# Access Compliance Report

## Public Rights-of-Way

Intersection ID: 46375	Main Street: HONOR_GUARD_AV	Cross Street: ROYAL_CASTLE_CT	Location: NW
ADA ID: 31DEEE1EE9E5	Ramp Type: PerpDiag	Initial Pass/Fail: Fail	Overall Compliance: No
			Severity Score: 21.25

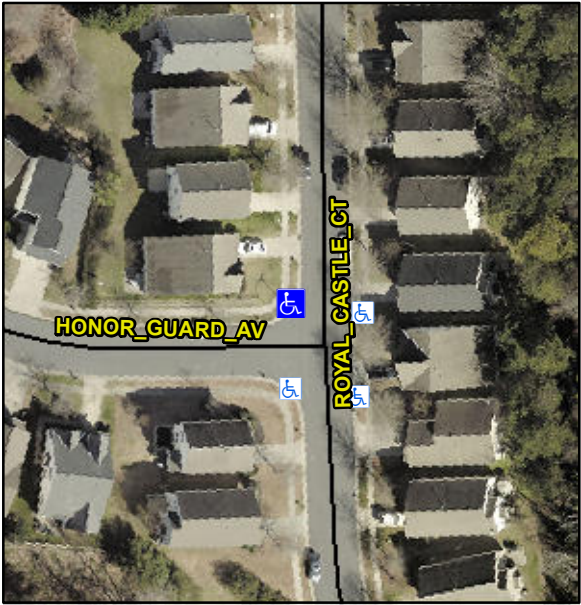
Codes/Mitigation Info/Possible Solution			Field Measurements/Component Compliance		
	Possible Solutions:		<b>Compliance</b>	<b>Description</b>	<b>Data</b>
	<b>Remove &amp; Replace Curb Ramp With Two New Directional Ramps or Equivalent.</b>		<b>Yes</b>	Ramp Slope (%)	7.5
			<b>No</b>	Ramp XSlope (%)	6.4
			<b>N/A</b>	Flare Type LT	N/A
			<b>N/A</b>	Flare Slope LT (%)	N/A
			<b>N/A</b>	Flare Traversable LT?	N/A
			<b>N/A</b>	Landing Length (in)	N/A
			<b>N/A</b>	Landing Width (in)	N/A
			<b>N/A</b>	Landing Slope (%)	N/A
			<b>N/A</b>	Landing X Slope (%)	N/A
			<b>N/A</b>	Landing Curb? (Y/N)	N/A
			<b>N/A</b>	Shared Landing?	N/A
			<b>N/A</b>	Gutter Ponding?	N/A
			<b>N/A</b>	Gutter Lip Ht (in)	N/A
			<b>No</b>	Painted X Walk1?	No
			<b>To S</b>	X Walk 1 Direction	To E
			<b>N/A</b>	X Walk 1 Width (in)	N/A
			<b>5.1</b>	X Walk 1 Slope (%)	1.6
			<b>2.1</b>	X Walk 1 X Slope (%)	3.8
			<b>N/A</b>	Ramp inside XWalk1?	N/A

<p>Surveyor Notes:</p> <p><b>N/A</b></p> <p>PROW/ADA:</p> <p><b>R304.5.1, R304.5.3</b></p>			<b>N/A</b>	Ramp inside XWalk2?	N/A
			<b>6.4</b>	Road Slope (%)	N/A
			<b>1.9</b>	Road X Slope (%)	N/A
			<b>N/A</b>	Any Obstructions?	N/A
				Obstruction Type	
			<b>N/A</b>		N/A
			<b>N/A</b>		N/A
			<b>Yes</b>	Surface Condition? (G/P)	Good
Street 1 Name	HONOR GUARD AV				
Stop Condition-Street 2	StopSign				
Street 2 Name	ROYAL CASTLE CT				
Stop Condition-Street 1	None				
Total Cost:	\$	3200.00
